Access Compliance Report

Public Rights-of-Way

Intersection ID: 52931	Main Street: WALTHAM_LN	Cross Street: GRAY_OAK_LN	Location: W
ADA ID: BC97757EDFD1	Ramp Type: Perp	Initial Pass/Fail: Pass	Overall Compliance: No
Severity Score: 0			
Codes/Mitigation Info/Possible Solution		Field Measurements/Component Compliance

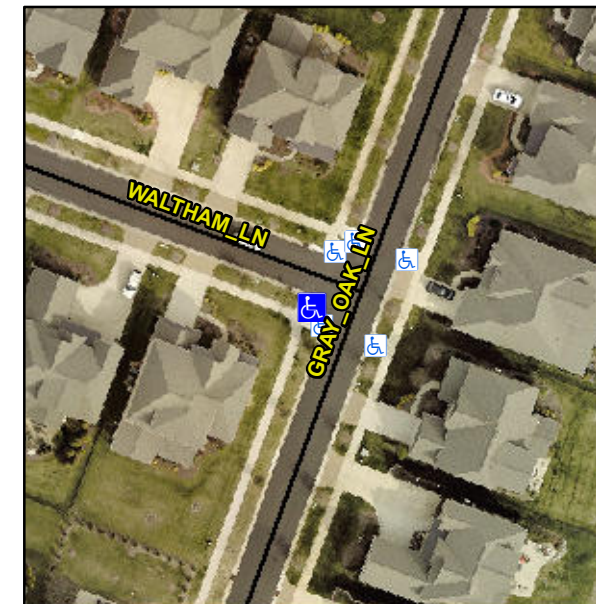
Remove & Replace Entire Ramp.

R304.5.3, R305.2
